**EXPLANATION OF SIGNIFICANT DIFFERENCES  
BREMERTON NAVAL COMPLEX  
OPERABLE UNIT B MARINE**

**February 2004**

FIGURE 1  
 OU B MARINE & NAVIGATION  
 DREDGING ACTION

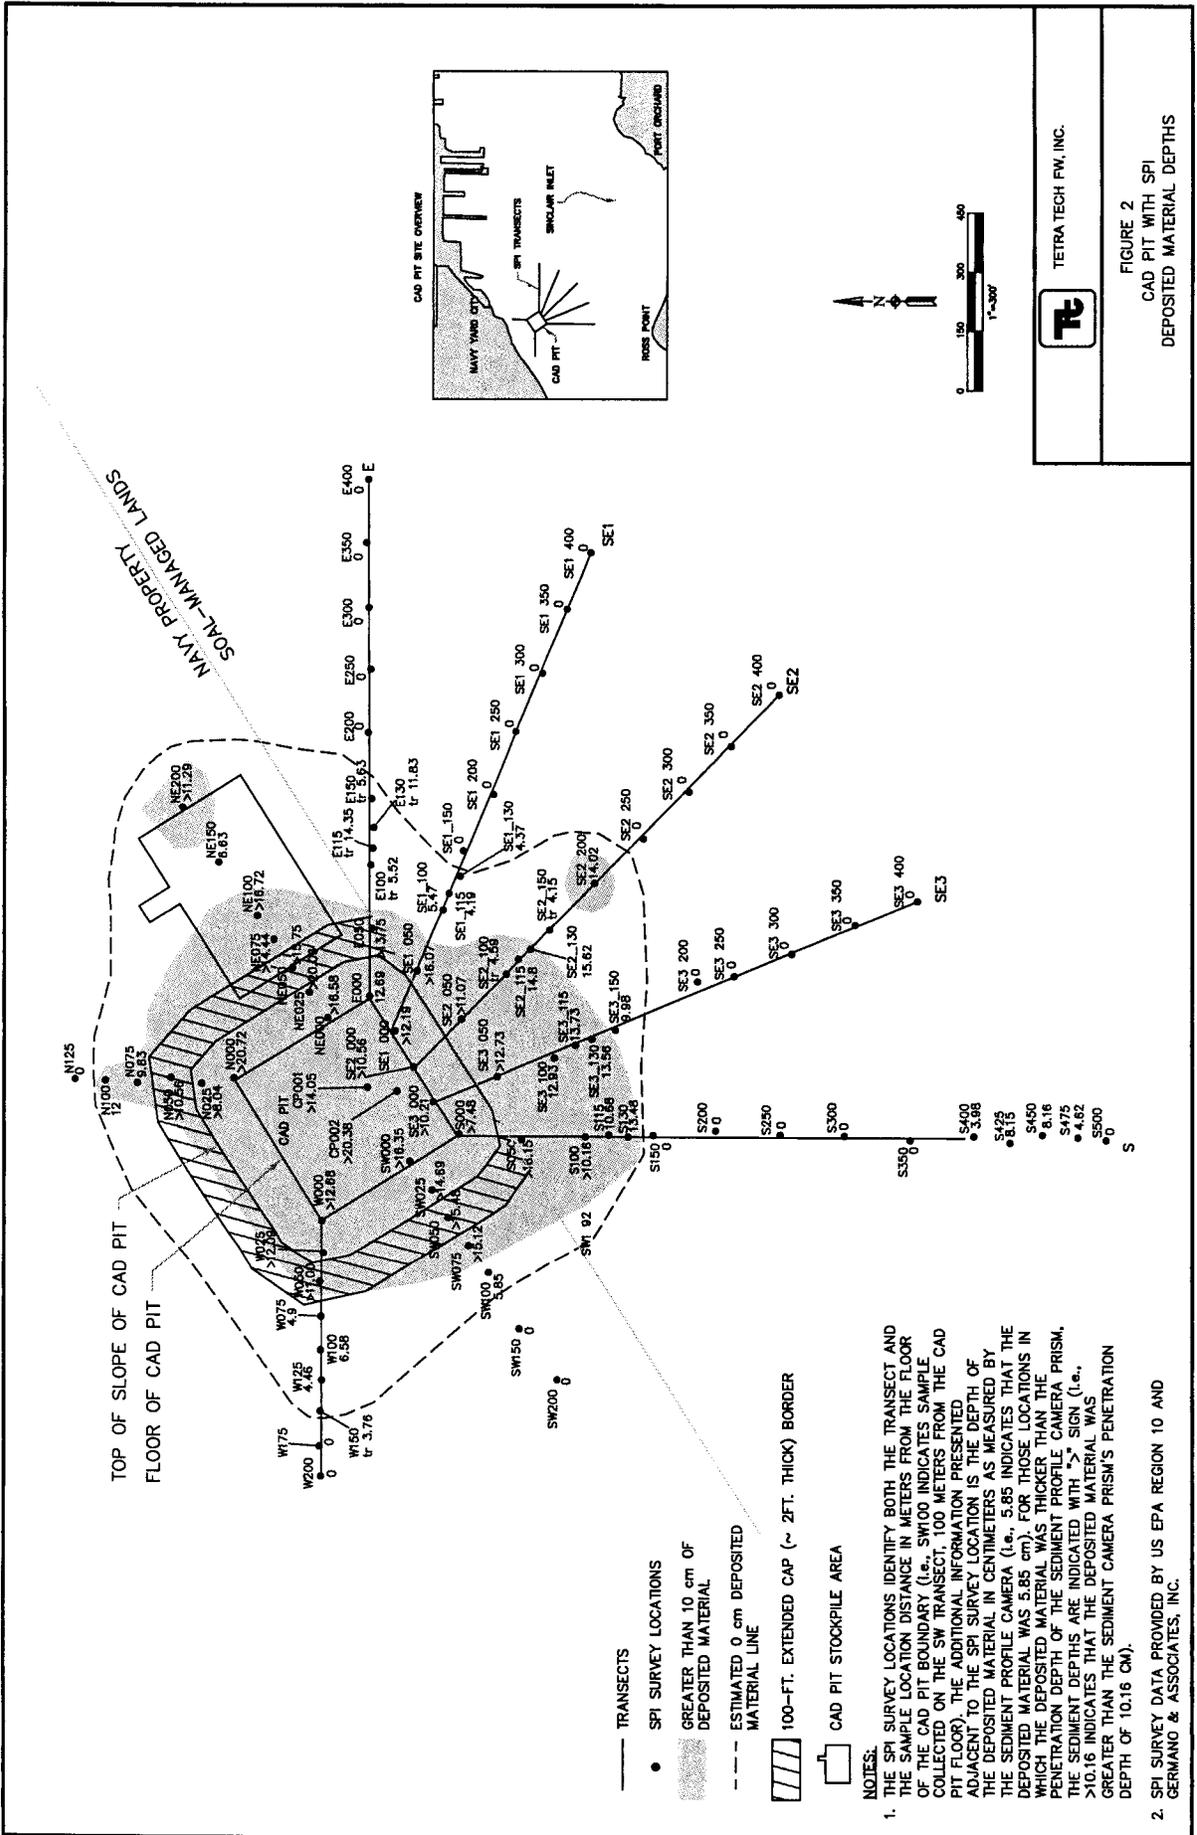
OU B Marine includes approximately 230 acres of subtidal land within Sinclair Inlet and extends up to 1,500 feet offshore of the terrestrial portions of the BNC to depths of approximately 40 feet below mean lower low water (MLLW). OU B Marine, as described in the ROD, is bounded to the north by the Sinclair Inlet shoreline and is bounded to the south by the Navy property line as shown in Figure 1.

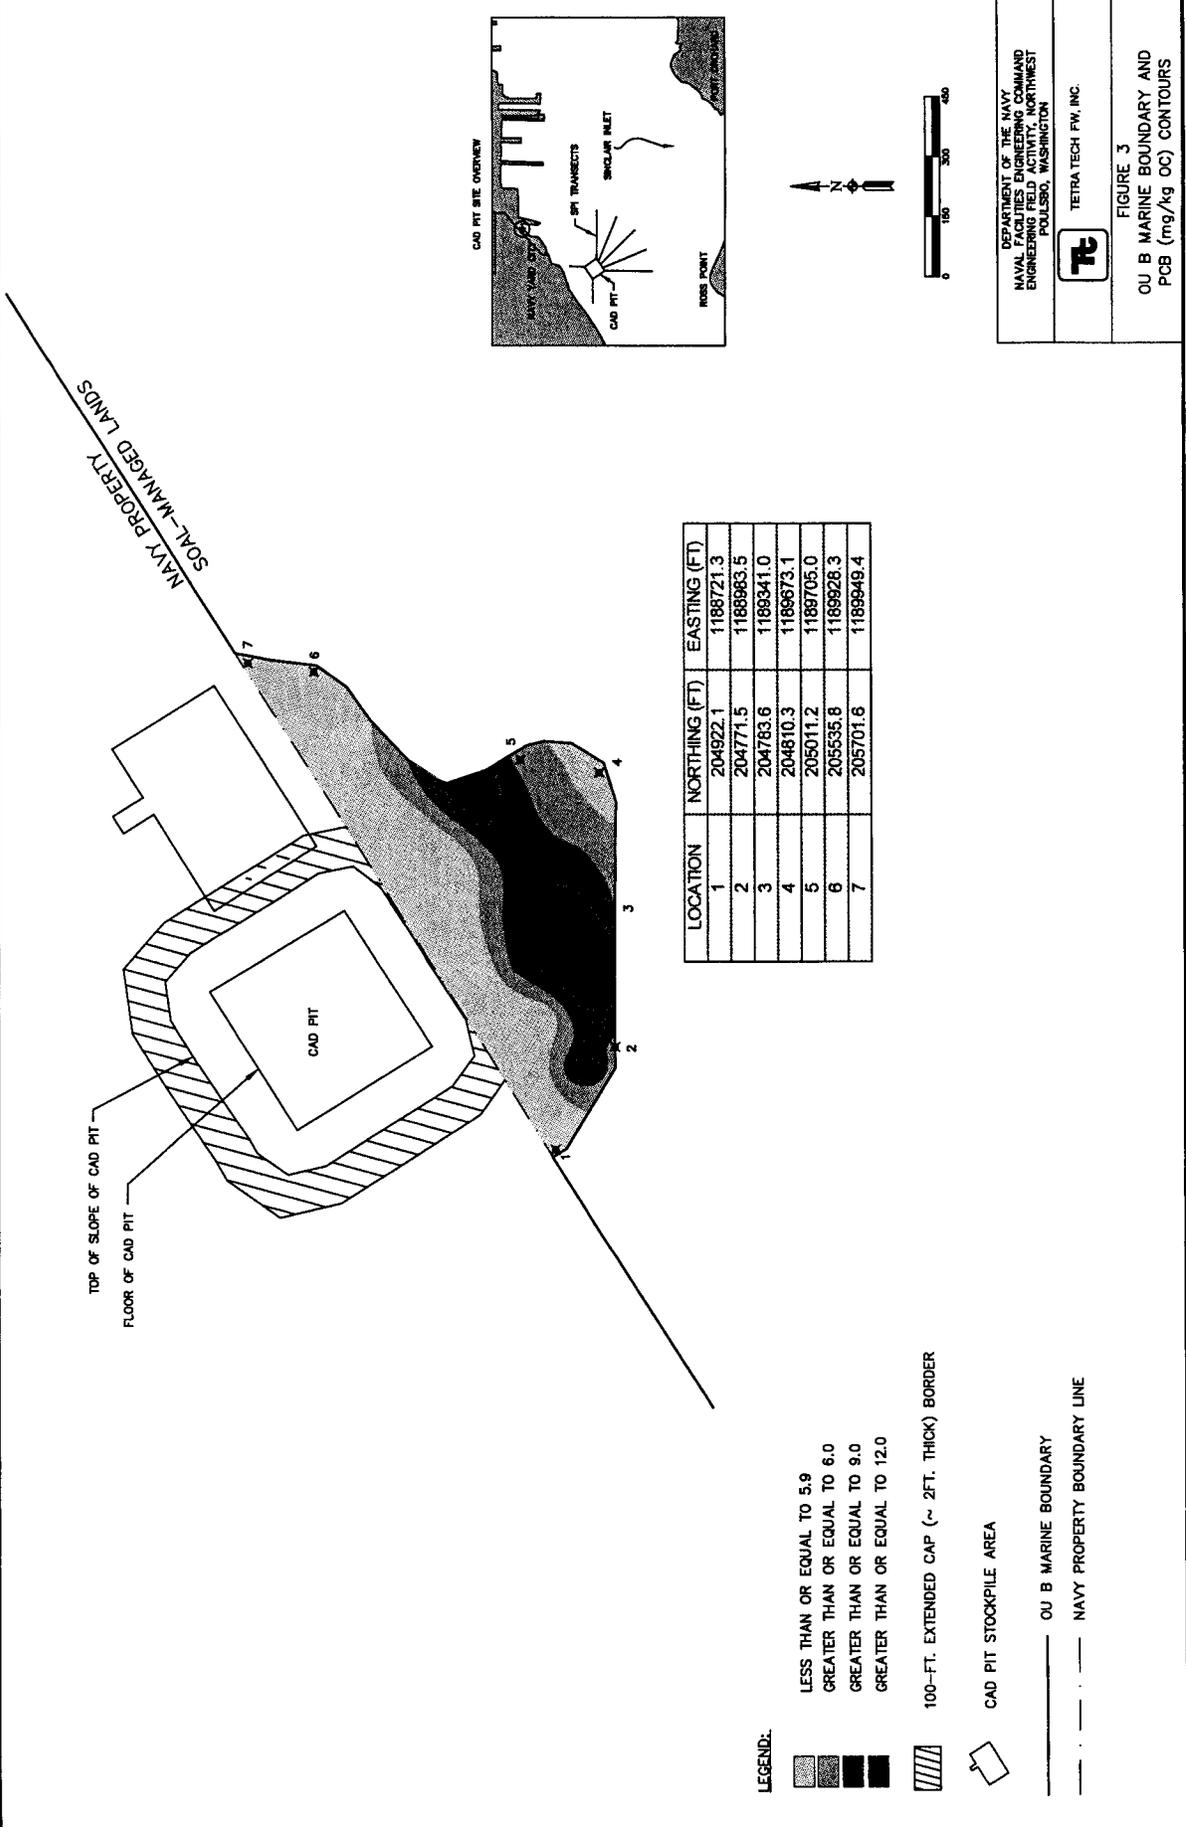
The boundary of OU B Marine is extended to include the area of impacted sediment on SOAL. The revised boundary of OU B Marine in the area of the CAD pit is depicted in Figure 3.

FIGURE 4  
 TURNING BASIN ENR  
 SOURCE MATERIAL

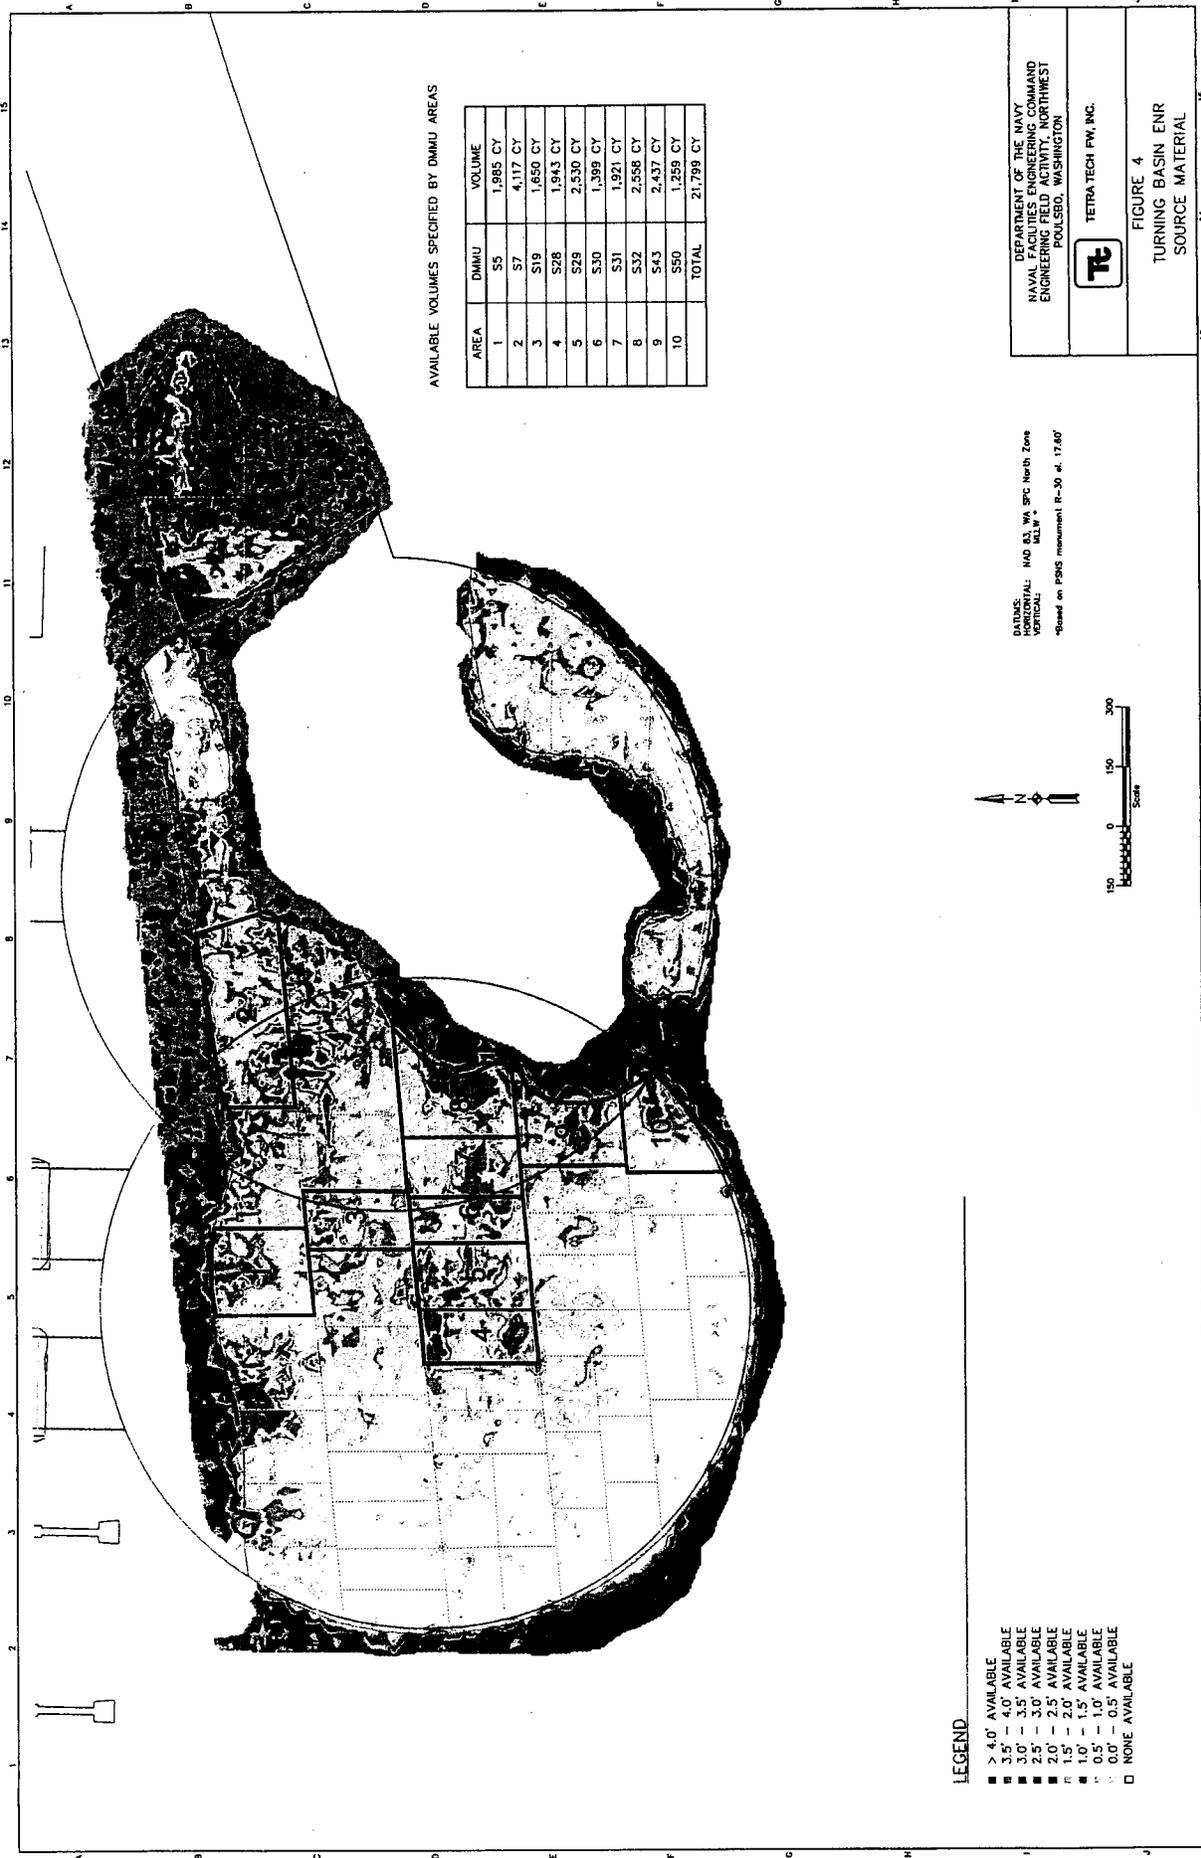
- Placement of 1-foot of clean material (enhanced natural recovery) in areas with sediment PCB concentrations of 9 mg/kg OC or greater.
- Clean material will come from undredged navigational turning basins that were previously characterized and approved for open-water disposal by the Dredged Material Management Office (DMMO). This material was beneficially used as capping material on the CAD pit. Figure 4 shows the proposed Dredged Material Management Units (DMMUs) that will be dredged to provide the sediment to complete the enhanced natural recovery. The turning basins are considered “on-site” in accordance with the “on-site” definition of NCP Section 300.5. The turning basins are immediately adjacent to OU B Marine and less than 1/3 of a mile from the impacted SOAL and meet the requirements of the definition to be “in very close proximity to the contamination” and “necessary for implementation of the response action.”
